**mcHF Hardware modifications as of April 29, 2015
as compiled by KA7OEI for
Version 0.3/4 UI and Version 0.4 RF boards**

The 4.7 ohm resistor added to the UI_8V line feeding U2, the audio amplifier.

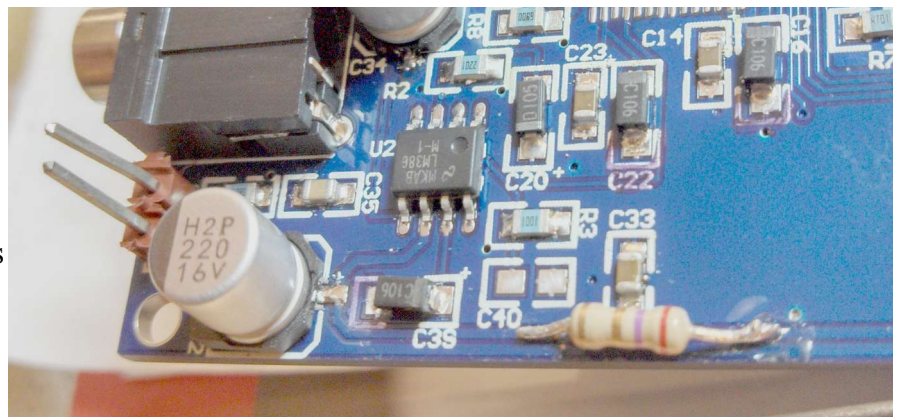
Reduction of conducted audio on the 8 volt line to prevent audio feedback (Version 0.3 and older UI boards only):

The insertion of a 4.7 ohm, 1/2 watt resistor in series (or two 10 ohm 1/8 watt resistors in parallel) with the +8 volt line, near the LM386 audio amplifier.

This is an important modification that fixes one source of oscillation at high volume levels.

The "U3a" modification, piggybacking another 74HC4066 atop U3 to prevent feedback into the receiver.

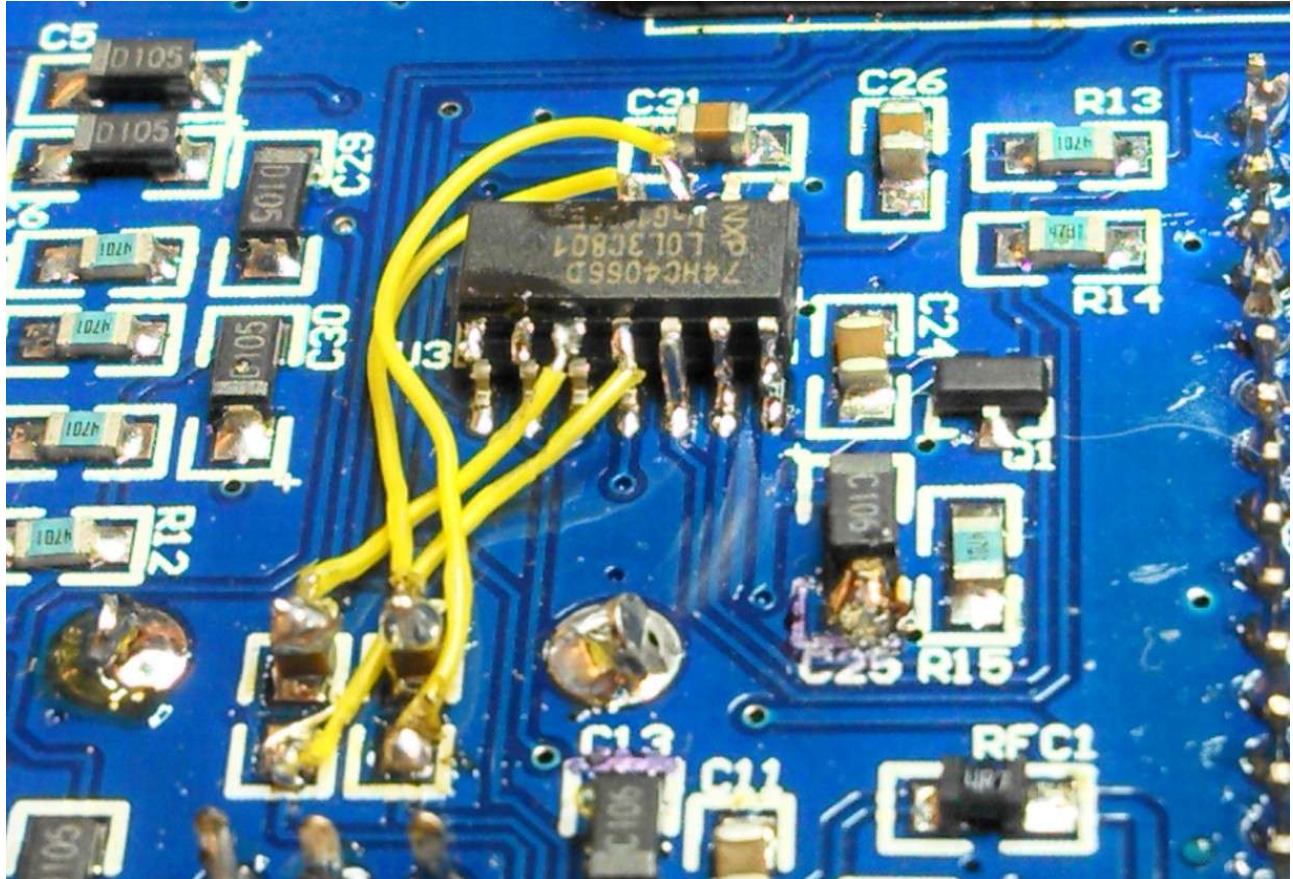
Prevention of RX audio “breakthrough” on the TX mixer (Version 0.3 and older UI boards only):

The installation of a which, which we call "U3a", is a 74HC4066 switch, piggybacked atop U3, and is a pretty easy mod if you have soldered the rest of the board!

This fixes a source of distortion/oscillation in the receiver, particularly at high volume levels and on high bands: **This is a very important modification that all users of this transceiver should perform.**

Take a 74HC4066 chip, of the same type and package as U3 and piggyback it atop U3 (on the UI board) and use its power supply and control signals. This chip will now be able to turn on/off the TX I and Q signals with a bit of fairly simple rewiring. Let us call this new chip "U3a"

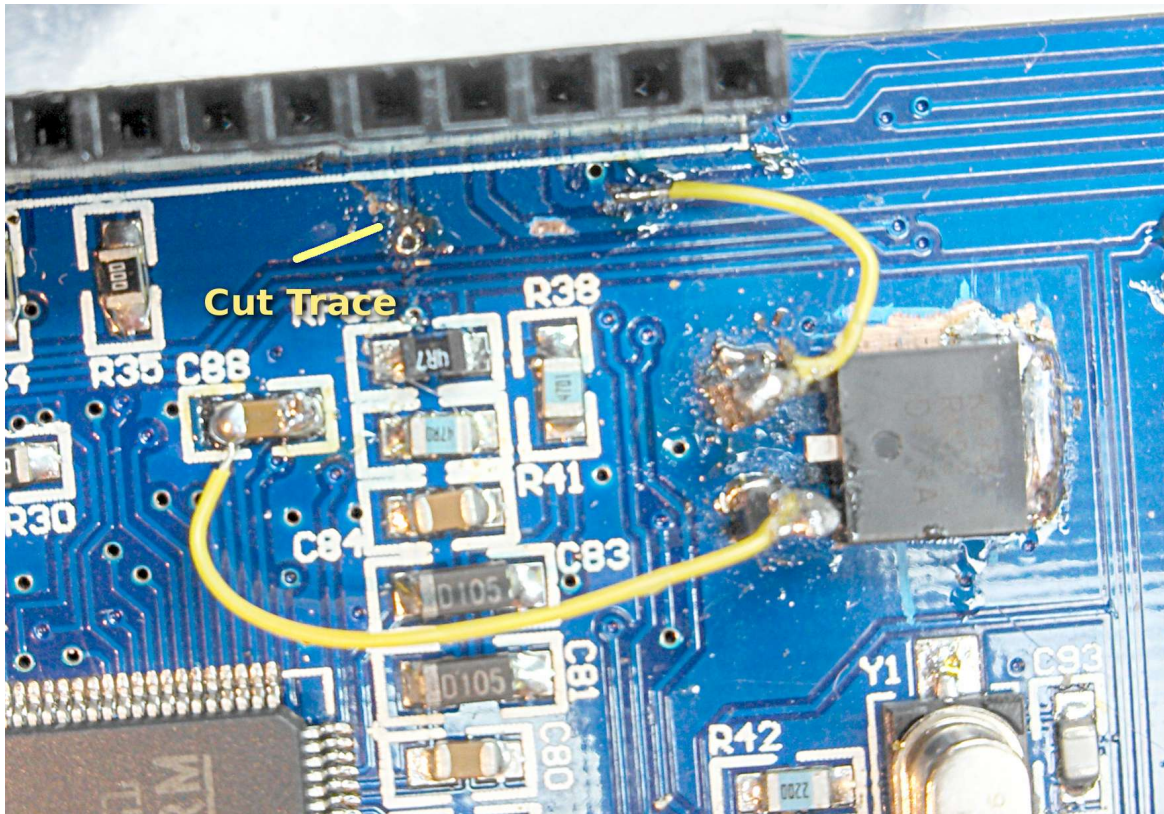
A separate 3.3 volt regulator for the MCU and additional LCD +5V filtering (Version 0.3 and older boards UI only):

This leads to the recommended installation of another 3.3 volt regulator on the UI board for the MCU: This mod is actually easier than the "U3a" mod and uses the same type of parts as those that you'd already have gotten (e.g. another 3.3 volt regulator and two more 10uF capacitors.) This reduces one source of low-level noise – much of it in the form of a 1.5 kHz “whine” – getting into the receiver due to the MCU's modulation of current on the 3.3 volt line shared with low-level audio circuitry. Taken together, these two modifications can improve the receiver sensitivity by 2-3 S-units, depending on band.

The trace to isolate the 3.3 volt supply feeding the MCU is indicated on the picture and it should be cut **just above the via** that goes through to the other side of the board. The 3.3 volt output from the added

Diagram depicting the MCU's own, isolated 3.3 volt power supply. This also shows additional isolation of the LCD power supply as well as the suggested, separate 5 volt power supply for the UI board - see text.

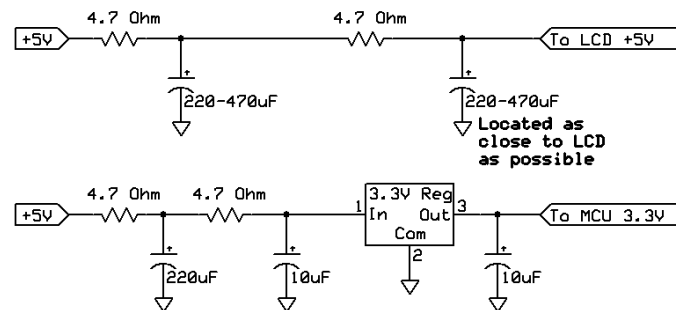
The diagram shows the filtering in schematic form. There is a voltage drop associated with each resistor, but each is well within the range of the associated device.

On the 3.3 volt MCU regulator, the 220uF capacitor on the input side of the 3.3 volt regulator, along with the 4.7 ohm resistors, form a low-pass filter that provides an impedance path between the noise source at the input of the regulator and the capacitor, greatly improving its ability to filter. The other 4.7 ohm resistor provides isolation between the noise that remains at the 220 uF capacitor and the rest of the 5 volt bus in the transceiver.

Note: Additional isolation will be obtained if the LCD, MCU and USB +5 volt supplies were derived from a separate 5 volt regulator on the UI board, powered from the +8 volt rail as depicted below.

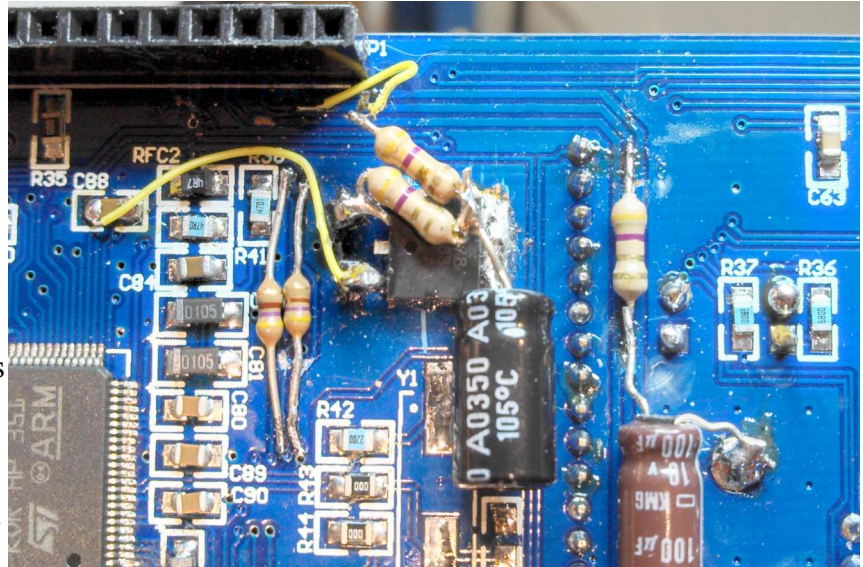
With the increase in sensitivity due to the reduced receiver background noise there may be the additional tendency for audio feedback to occur at high volume levels, particularly with no antenna connected *when using a speaker*. This is related to circulating currents on the UI board, some of which were addressed with the addition of the 4.7 ohm resistor in series with the 8 volt line on U2 noted earlier in this document.

This picture shows the location of the traces and where the cuts should be made. This is found to the right and above U4a, the MCU. A picture of a “bare” board is used for clarity.

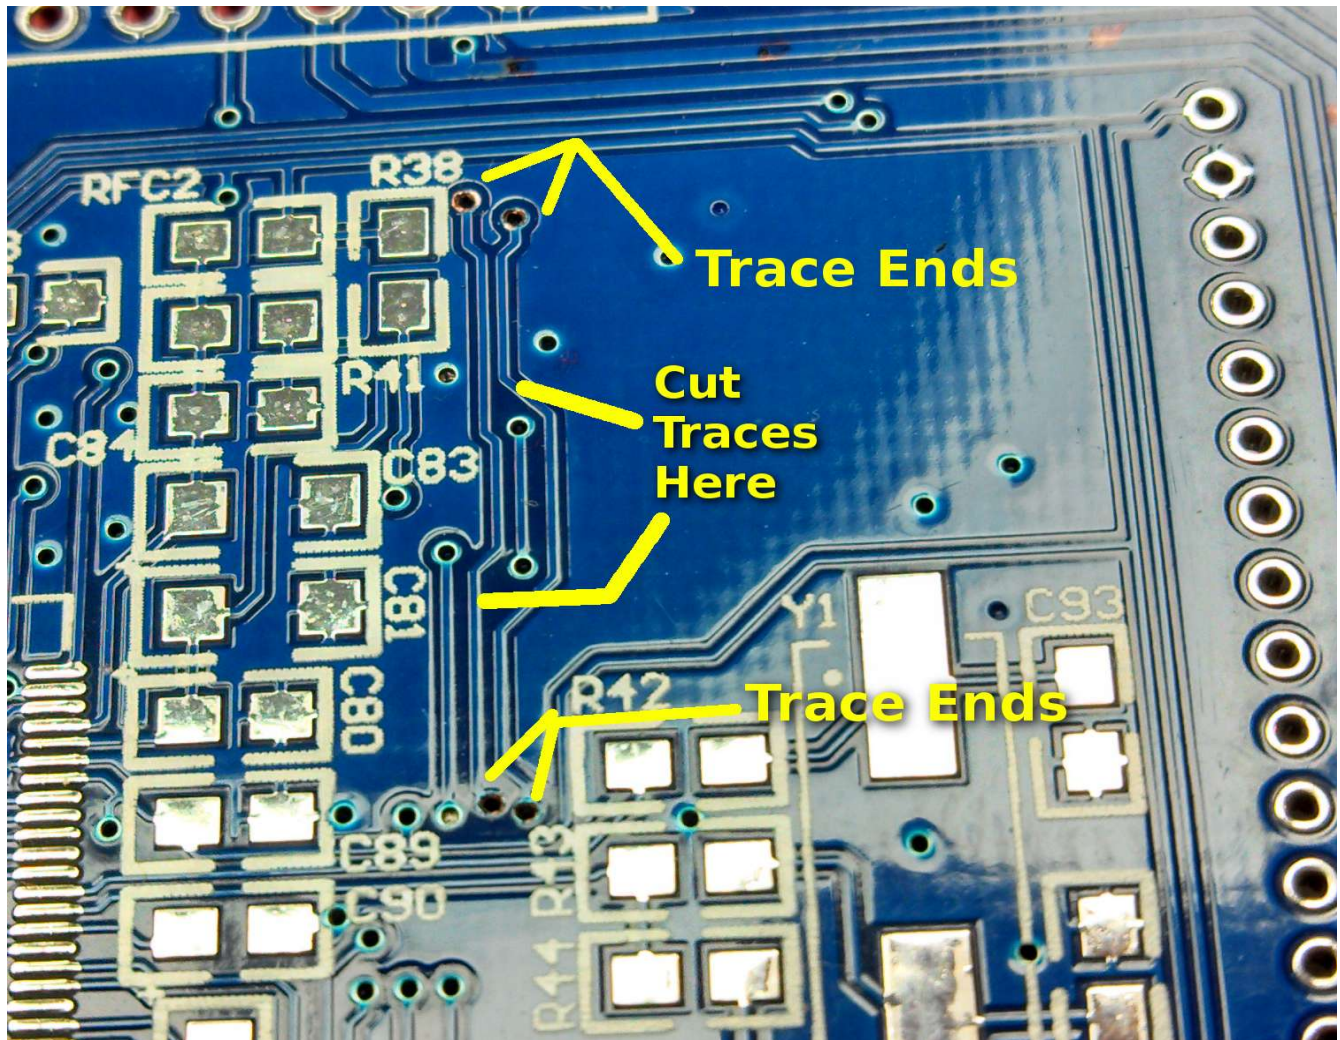
If the above modifications are made, with no antenna connected – or even with an antenna connected when listening on higher bands (especially 20 meters and above) a fairly strong “tick” may be heard every second. This is due to the polling of the onboard temperature sensor and the fact that the “fall” time of the on the I2C line from the MCU is extremely fast and rich with harmonic energy. This problem can be easily “fixed” with the addition of resistors on the UI board in series with the SCL and SDA lines which effectively reduce the slew rate of these lines, quashing the RF energy.

To identify the traces into which the resistors are to be installed, refer to the picture below:

A reasonable value of resistor to install is 470 ohms and the installed components may be seen in the picture.

The added 470 ohm resistors in series with the SCL and SDA lines. Note that this picture also shows the added 3.3 volt MCU regulator mentioned above. 1/8 watt, leaded resistors are used, but surface mount resistors could be used, if desired.

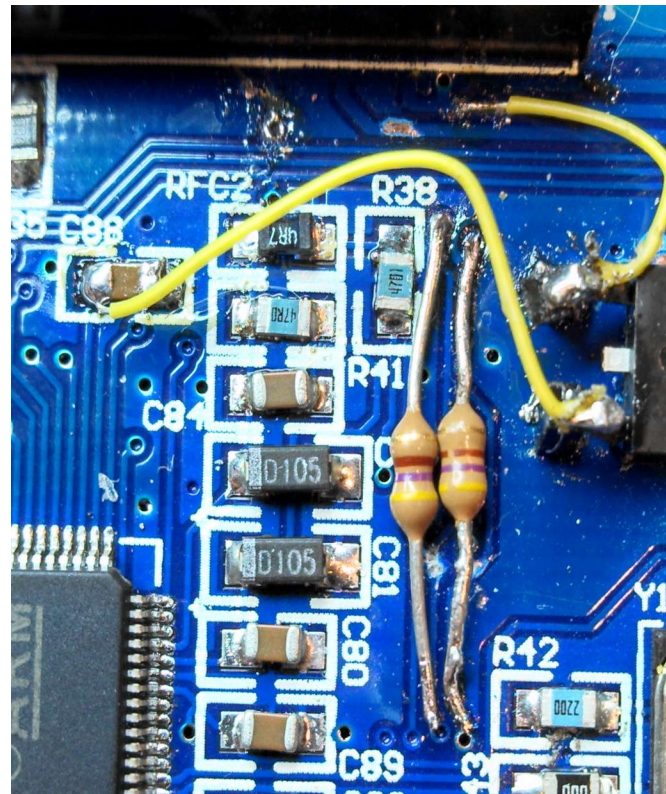
In the picture can be seen the two added 470 ohm resistors. As you can see, I used leaded 1/8 watt resistors, but surface mount resistors can be used, instead if that is your preference. (The 3.3 volt regulator used for the MCU – see the modification earlier in this document – can be partially seen.)

This modification appears to be **completely** effective in removing the “tick” noise from the higher bands and does not appear to compromise the operation of the I2C data stream in any way.
